B. TEXT OF THE REGULATION

DYNAMIC POLE SIDE IMPACT TEST PROCEDURE

PITCH AND ROLL ANGLE REFERENCES

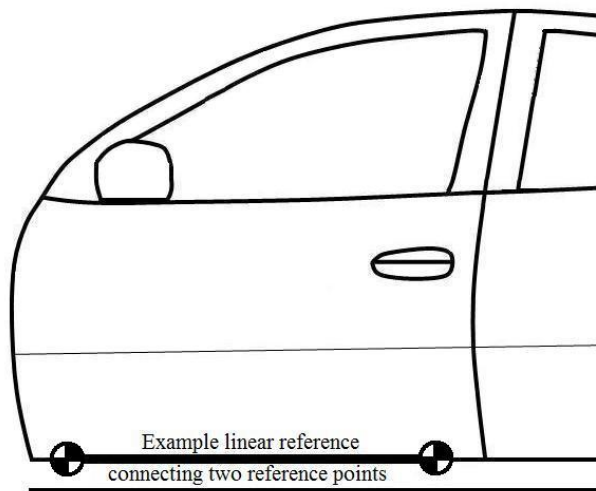
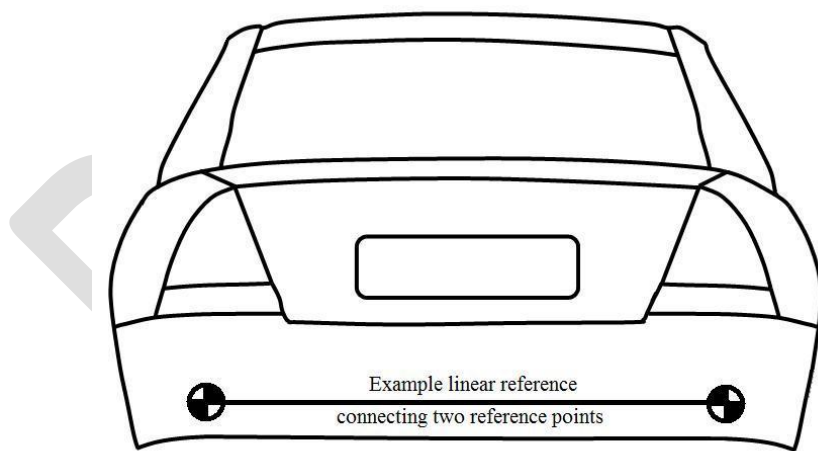
Comment [tb257]: Australia to modify figures to show example pitch and roll angles relative to the level surface or horizontal reference plane.
